ASB-987

## Service Bulletin

<p><b>Subject: TH-205/215/315/415 PTT KNOB INSTALL PROCEDURE</b> <b>Date June 11,</b> <b>1990</b></p>
---------------------------------------------------------------------------------------------------------------

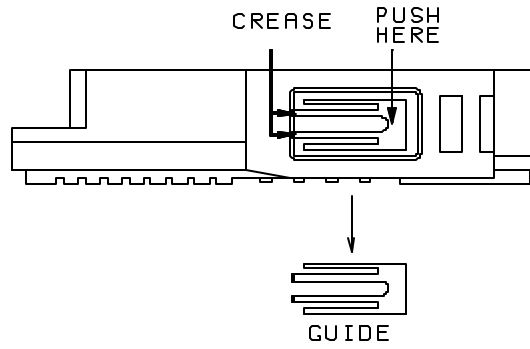
The original plastic knob (K29-3054-15) has been replaced with a rubber knob (K29-3054-35). The PTT mounting guide on the front panel must be removed to allow the new knob to be installed. The following procedure will explain the installation procedure.

1. Disconnect the battery pack and antenna.
2. Remove the four screws from the back panel.
3. Carefully lift the front panel up and lay it to the right side of the body of the transceiver.
4. Disconnect the front panel from the body of the transceiver.
5. The plastic PTT knob is held in place with three tabs. Press in the bottom tab and then push the knob out of the front panel.
6. Push in the guide to crease it's two legs where they join the front panel.
7. Wiggle the guide back and forth until it breaks off the front panel. Discard the guide and plastic knob.
8. Install the rubber knob on the front panel. The side with the square tab goes toward the bottom of the front panel.
